RE: TEDS Exception No. 37-03, from Minimum Vehicle Storage for a Drive-up Branch
Banking Facility

DESIGN EXCEPTION #DE37-03

RE: TEDS Exception: 1st National Bank of the Rockies CUP, 685 Horizon Drive
CUP-2003-181

SUBJECT: TEDS Exception for First National Bank of the Rockies at Safeway Center
on Horizon Drive.

TABLE B
SUMMARY OF OBSERVATIONS

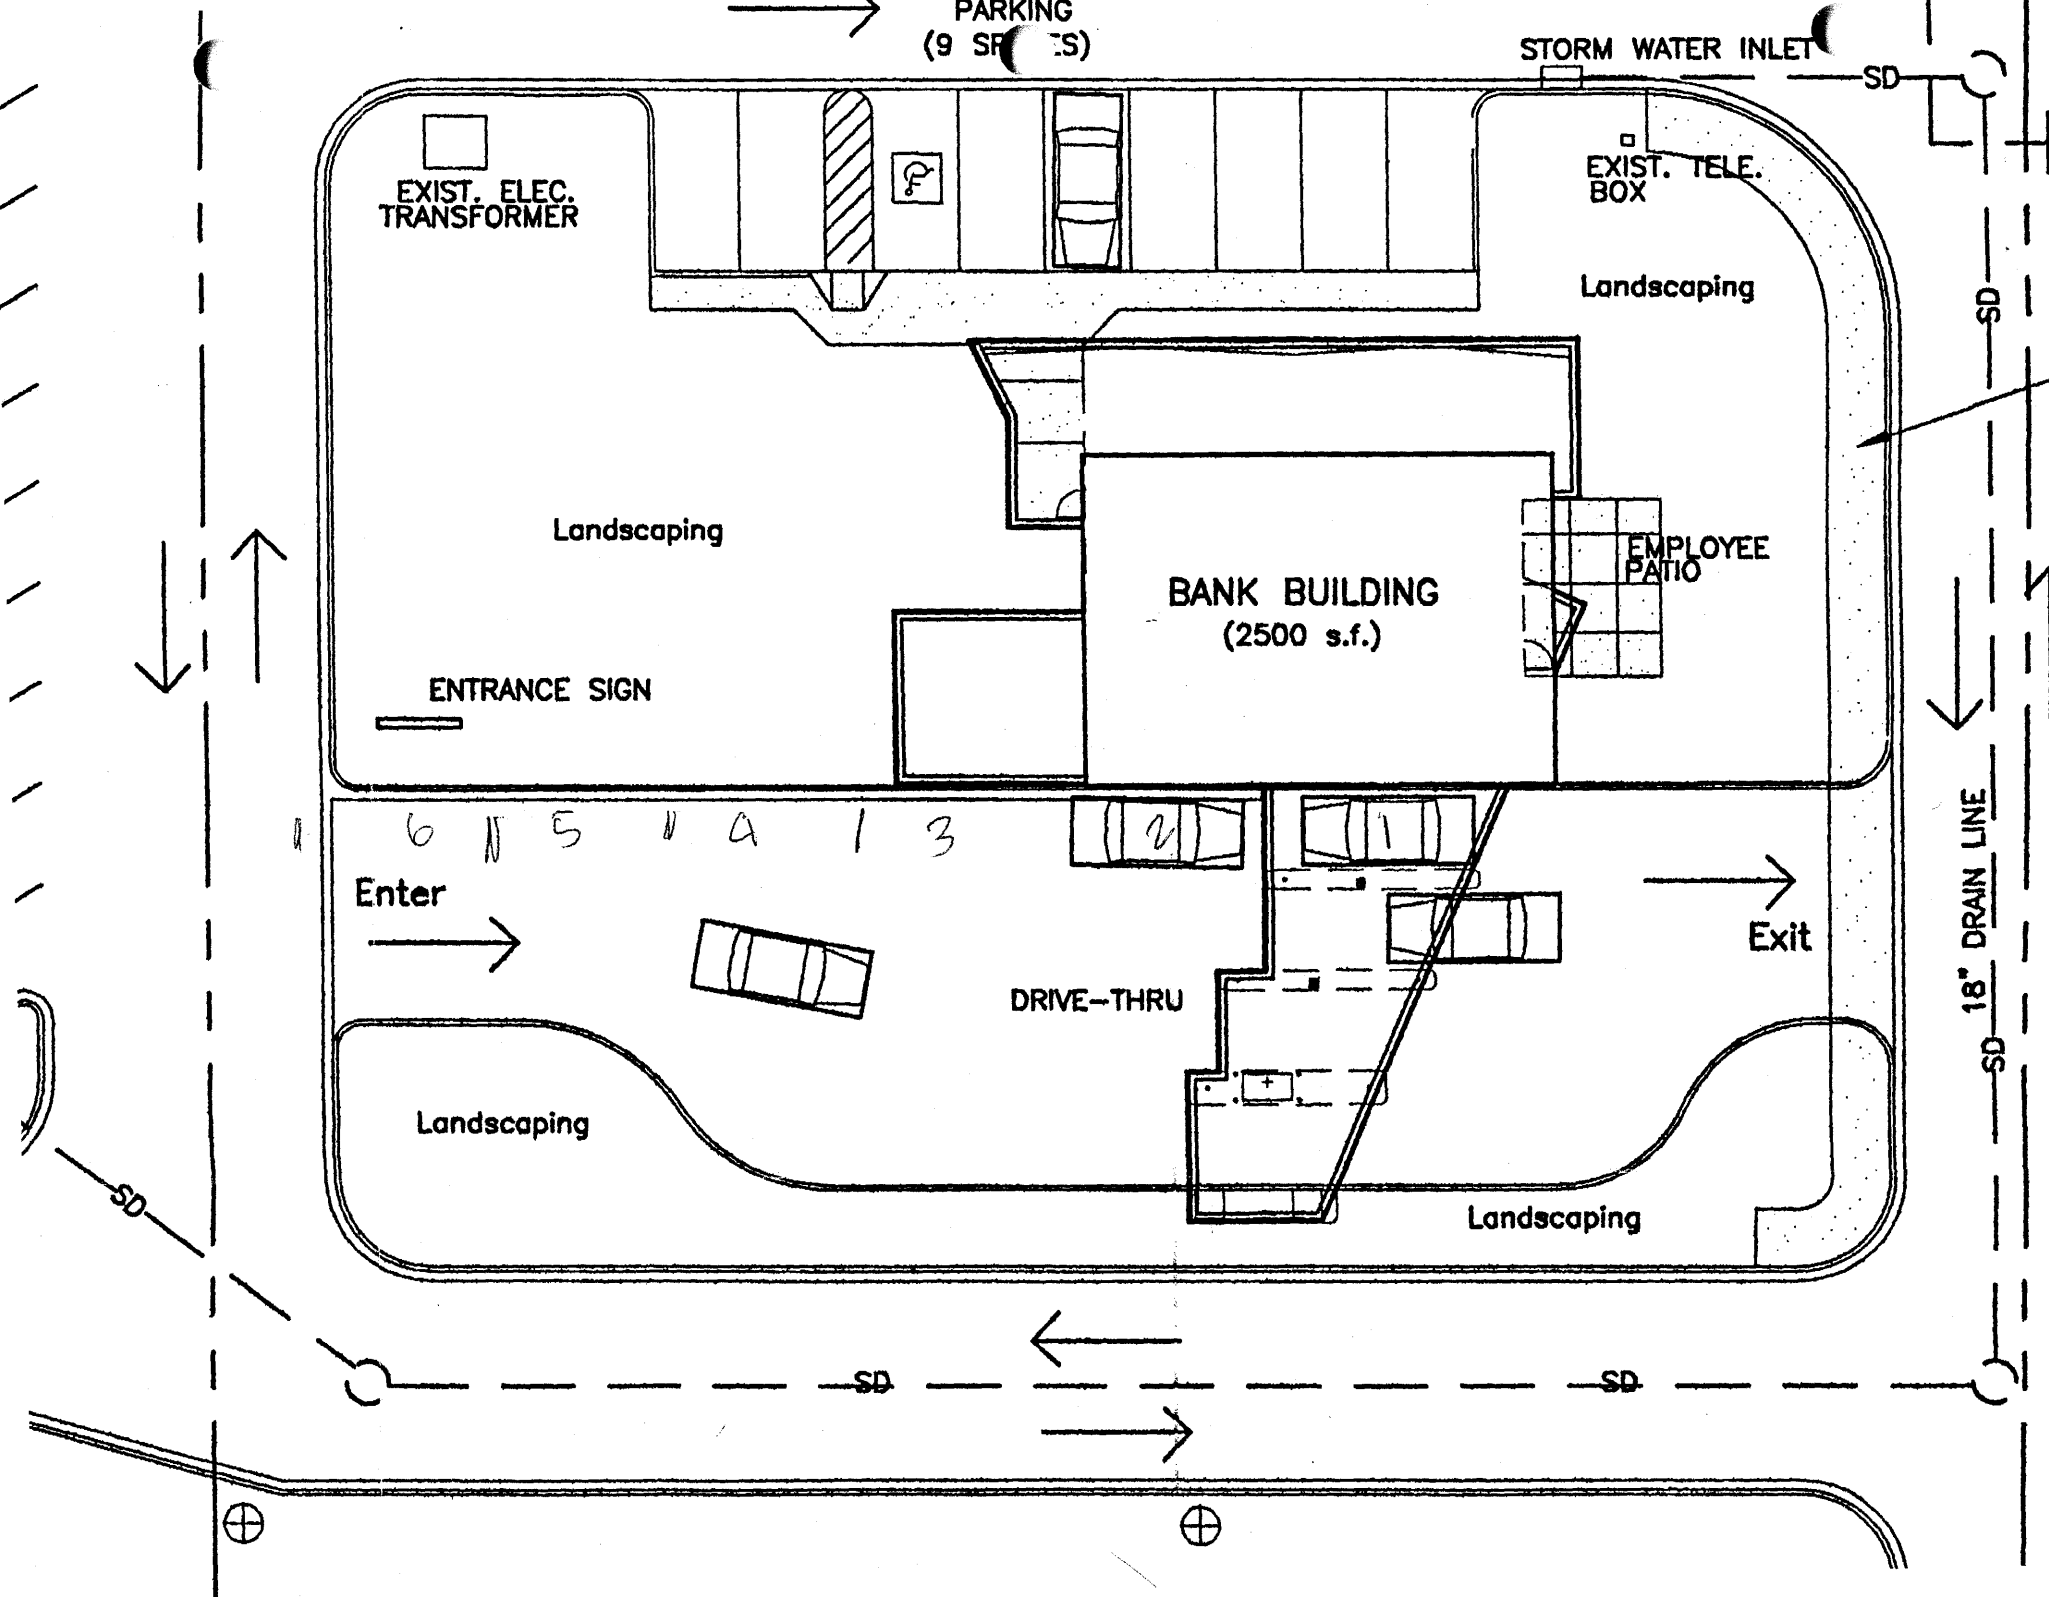
- 9 times out of 120 / 5-minute intervals did all aisles become occupied.
- 22 times out of 120 / 5-minute intervals did 2 cars queue the same aisle.
- 1 time out of 120 / 5-minute intervals did 3 cars queue the same aisle (this was to use the ATM machine).
- The average queue for all aisles for all drive-ups were a high of 0.58 cars to a low of 0.319 cars.
- 27 times out of 120 / 5-minute intervals did all aisles become unoccupied.
- In all cases, where the aisles extended out from the building, the maximum number of queues occurred at the drive-up window closest to the building and descended in numbers the further away the aisles were (exception – the ATM machine use in the furthestmost aisle).
- As can be seen in table A, the average queue in each lane was less than one vehicle.
